Legislation Details (With Text)

File #: 18-00304 **Version:** 1 **Name:**
Type: Legislative Action Item **Status:** Withdrawn
File created: 7/27/2018 **In control:** City Council
On agenda: 8/9/2018 **Final action:**
Enactment date: **Enactment #:**
Title: PUBLIC HEARING: PROPOSED AMENDMENT TO THE LAND DEVELOPMENT CODE - CREATING SECTION 12-2-25, PROVIDING FOR THE CRA URBAN DESIGN OVERLAY DISTRICT

PUBLIC HEARING: PROPOSED AMENDMENT TO THE LAND DEVELOPMENT CODE - CREATING SECTION 12-2-25, PROVIDING FOR THE CRA URBAN DESIGN OVERLAY DISTRICT

Table 12-2-25.3 -Single Family Detached and Two-Family Attached (Duplex) Residential Building Types- R-1AAA through R-1A

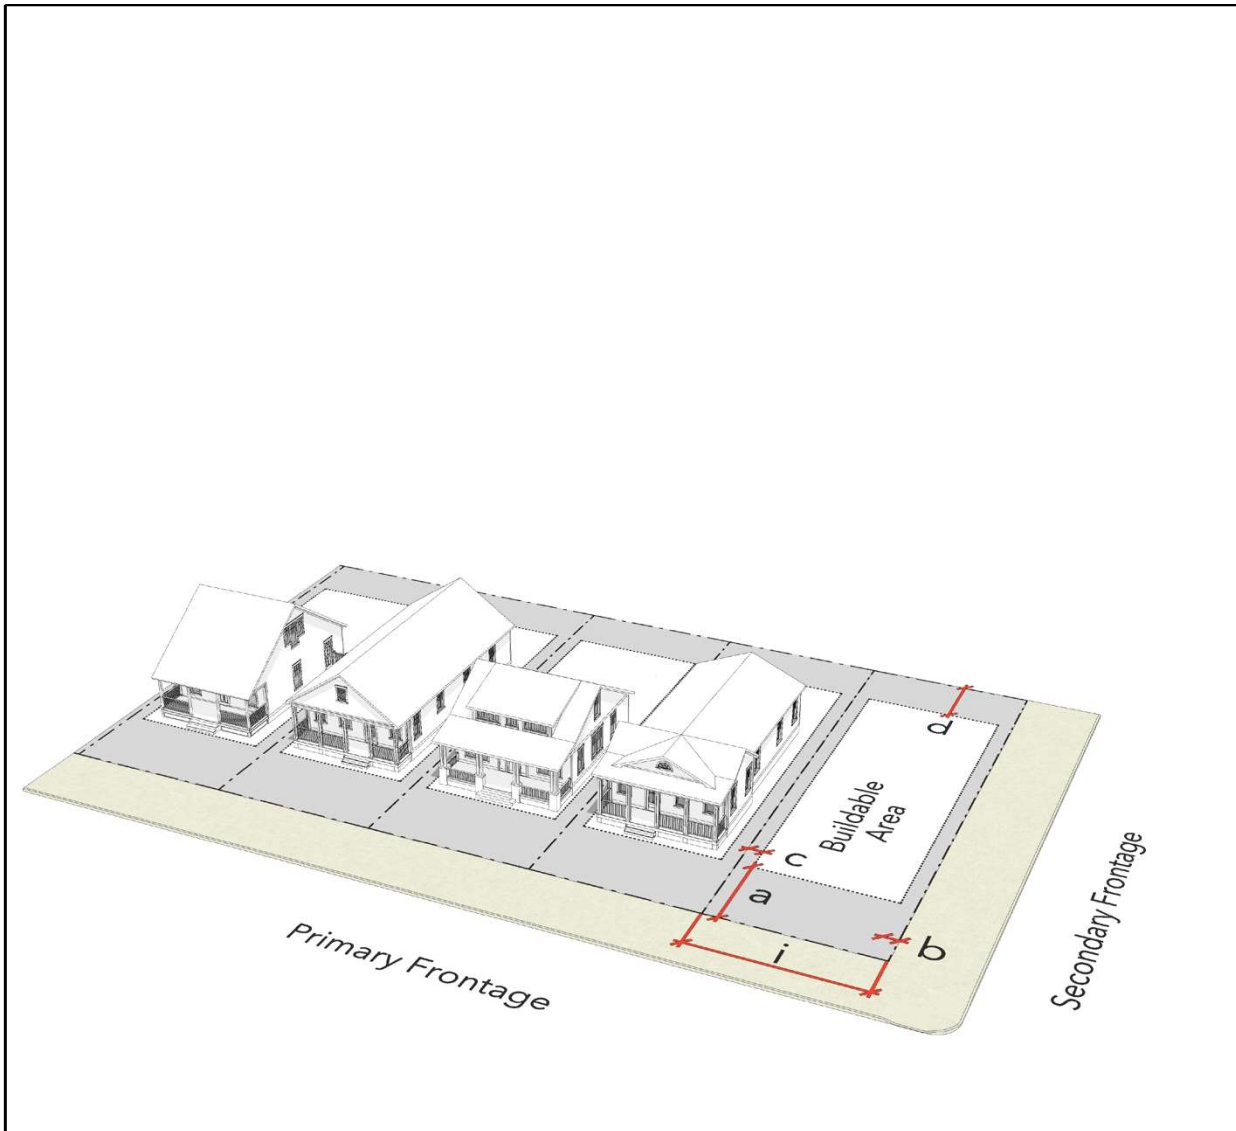
- b. Accessory building rear setbacks for single family residential buildings should be reduced from a minimum of five (5) feet to a minimum of three (3) feet to adhere to the underlying standard.
- c. Side and rear setbacks for single family detached and duplex developments on thirty-foot (30') lots should be reduced as follows:
 - a. Side setback reduction from five (5) feet to three (3) feet for single family detached and duplex buildings (Tables 12-2-25.3 and 12-2-25.4).
 - b. Rear setback reduction from 25-30' to 20' for single family detached and duplex buildings (Tables 12-2-25.3 and 12-2-25.4).

- (1) Measured according to Section 12-2-25(G)(a)(c).
- (2) See Section 12-2-25(G)(h)(b) for exceptions.
- (3) Lot width shall only be measured from the right-of-way line. Lot width at the building setback
- (4) [Minimum side yard setback for thirty-foot \(30'\) lots shall be three \(3\) feet measured from the required per applicable Florida Building Code.](#)
